Flight Procedures Cover Page	Task Action: FLIGHT CHECK	Task Type: IAP	Estimated Chart Date: 12/02/2021	APWS Task ID: 93E64ACC05944CB880FFCD9510449F4F	APWS Project ID: 9E23E099A9A64C4C845EC3D452012776
Procedure: RNAV (GPS) RWY 25 AMDT 2		Enroute: NO	Specialist: Hill, Casey		Agreement Number:
Airport ID: KFMN		Airport City: FARMINGTON			State: NM
Facility ID:	Facility Type:	Flight Inspection Remark Type: Hold FC Slot

RNAV (GPS) RWY 25

FARMINGTON/ FOUR CORNERS RGNL (F'MN)

**DEPARTMENT OF TRANSPORTATION
FEDERAL AVIATION ADMINISTRATION
CATEGORICAL EXCLUSION DECLARATION**

SW-1, 29 JUL 2010 to 26 AUG 2010

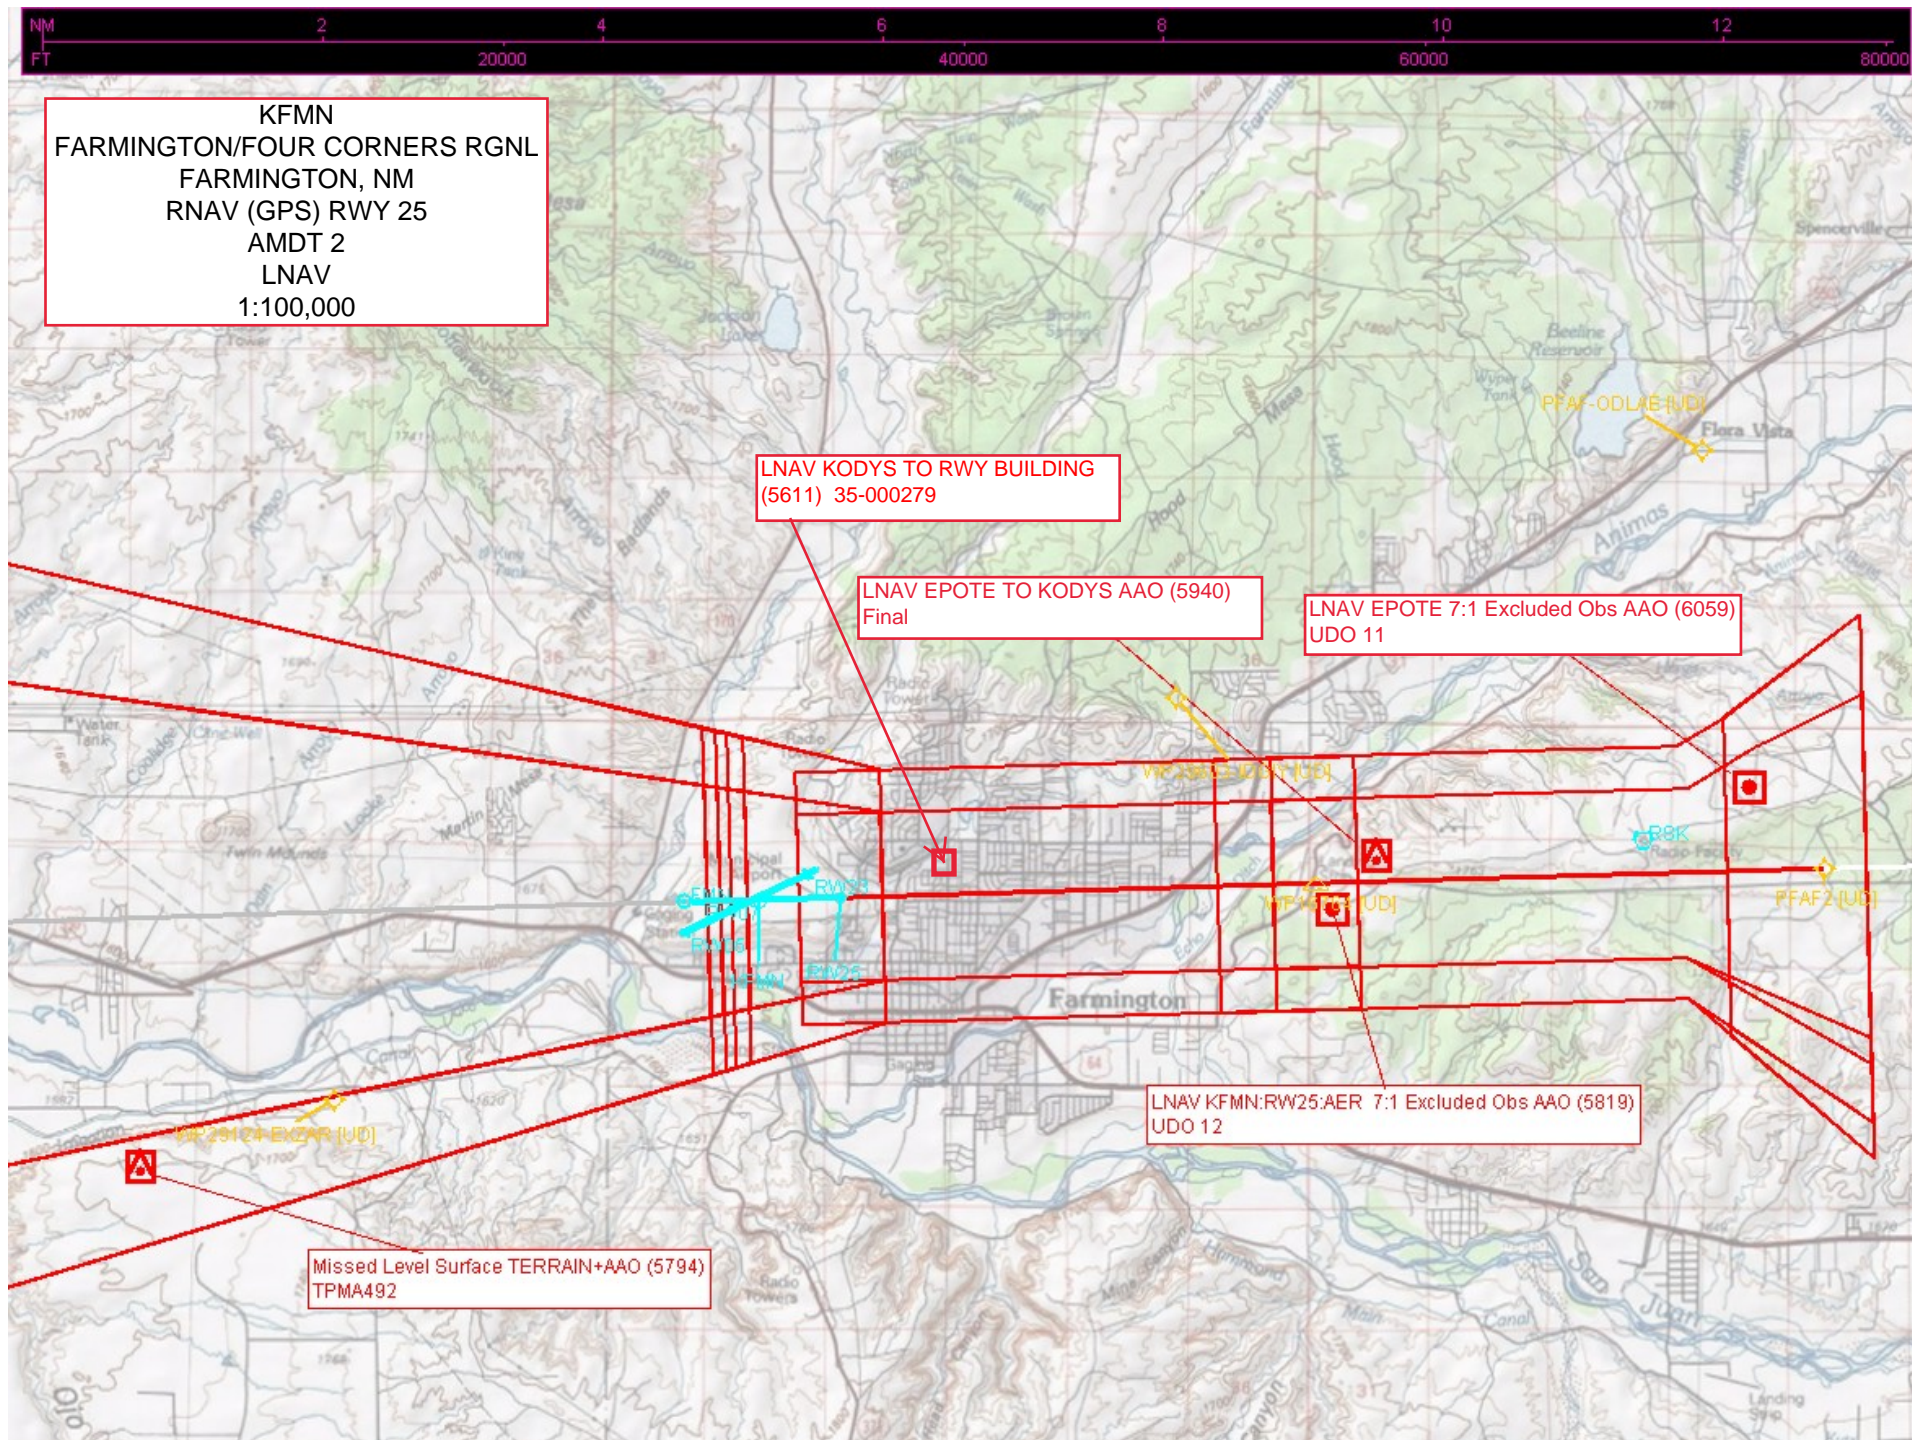
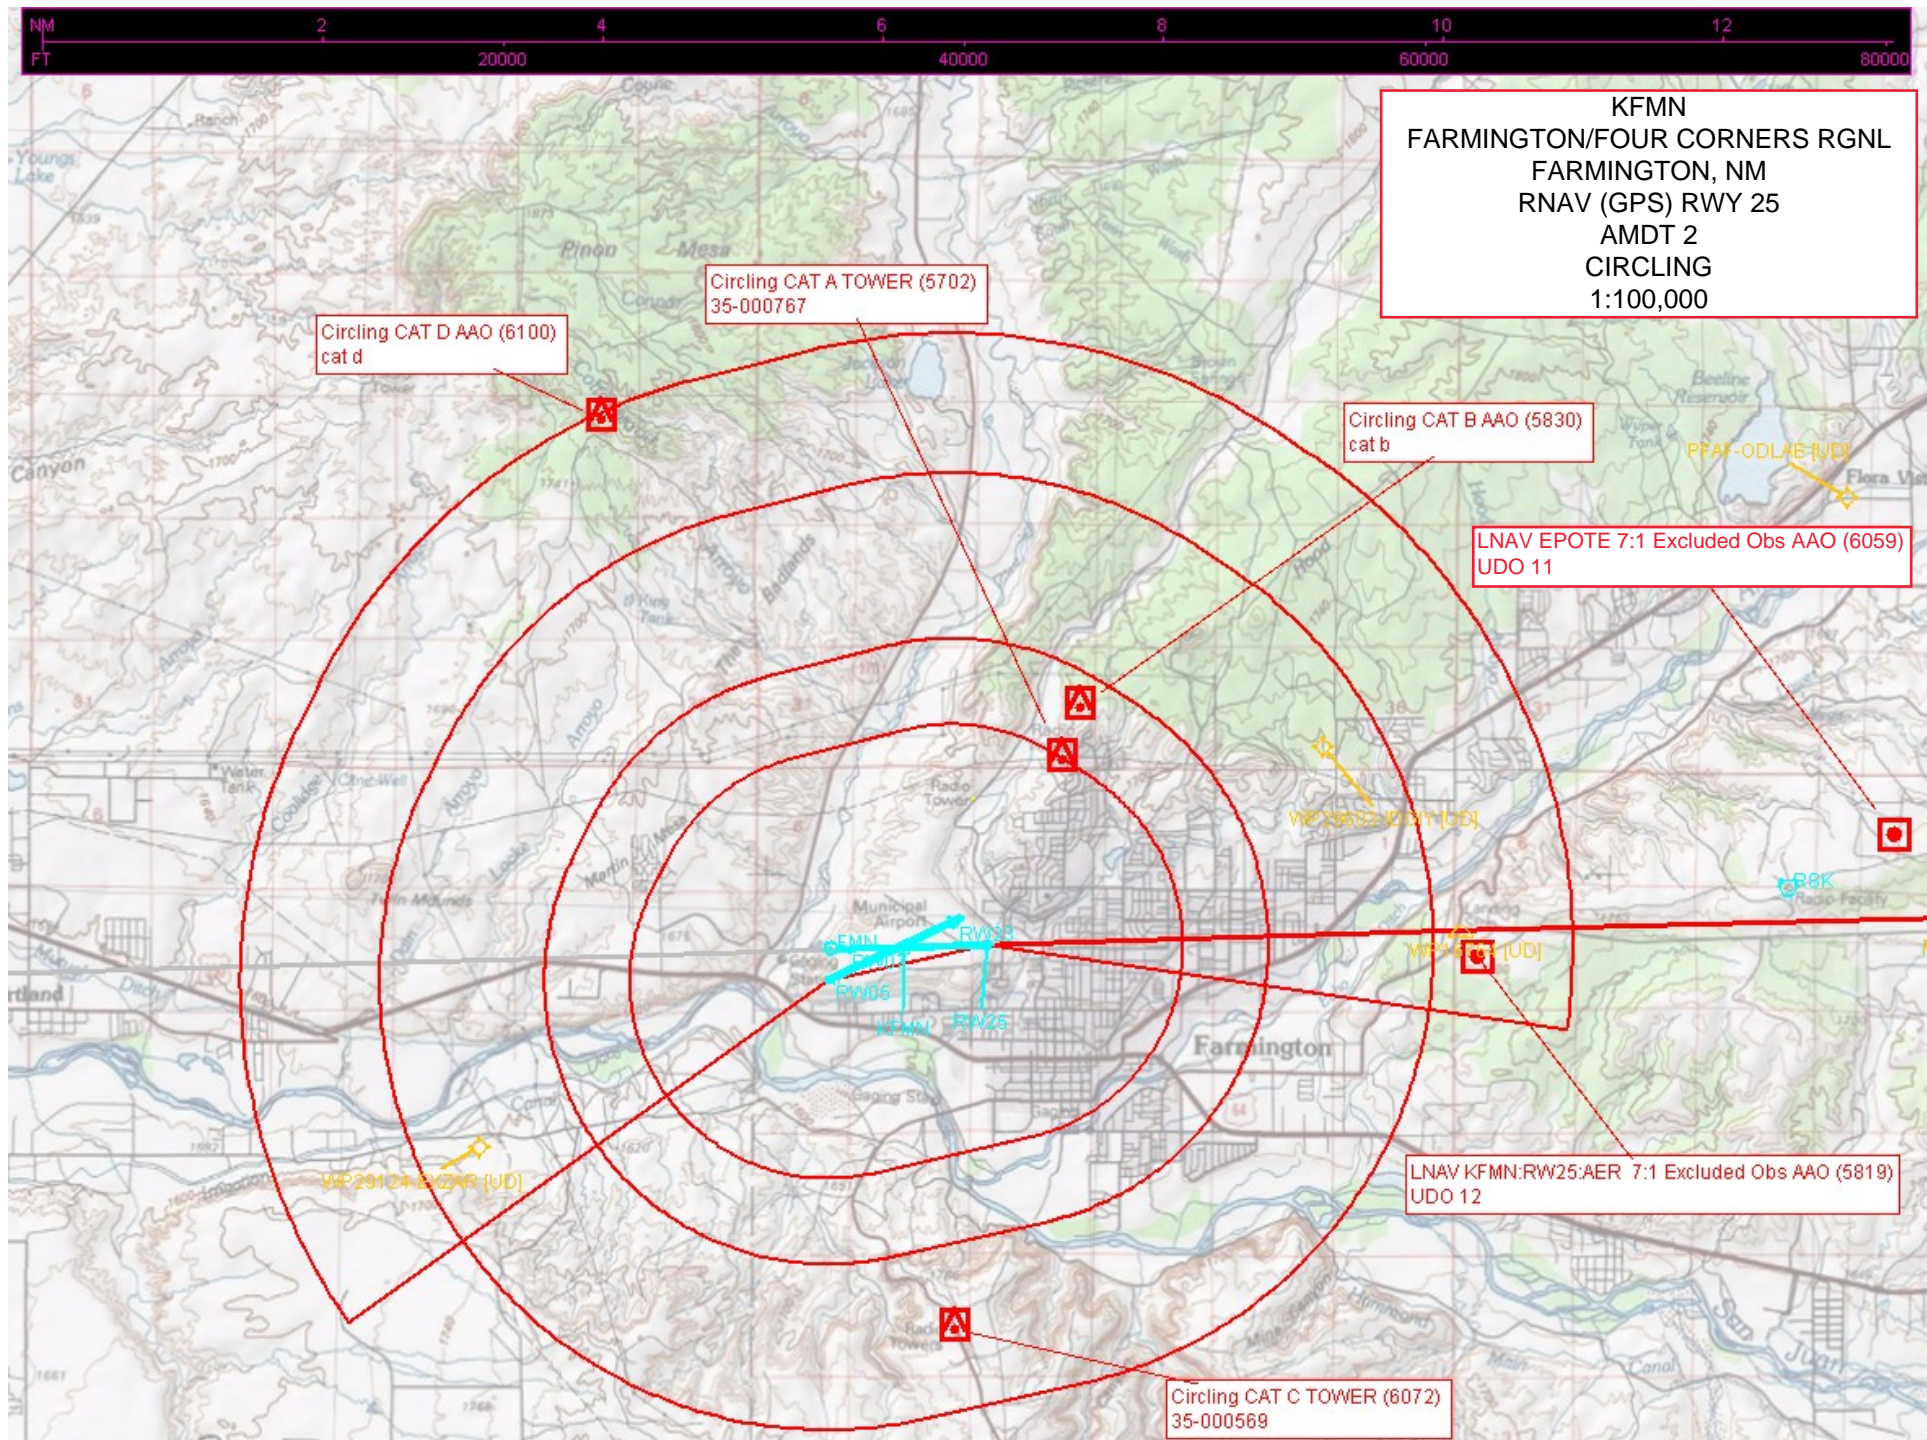
2. For RNAV (GPS) RWY 25: The proposed change deletes the existing Intermediate Fix (IF) CODEN and replaces it with a new IF POMEE, which will be located .69 Nautical Miles (NM) west of the current IF. Because the lateral change between the current and new IF is so small, the bearing to the Initial Approach Fix (IAF) TURLY will remain unchanged (251 degrees) as will the bearing to the secondary IAF MISSY (337 degrees). However, aircraft on both flight paths will track slightly differently (within one degree) from their historical flight tracks once the new IF POMEE is published.

3. For RNAV (GPS) RWY 25: There are currently two stepdown fixes on the final approach, but the proposed procedure will only use one stepdown fix. There will be no discernable change in where aircraft are flying.
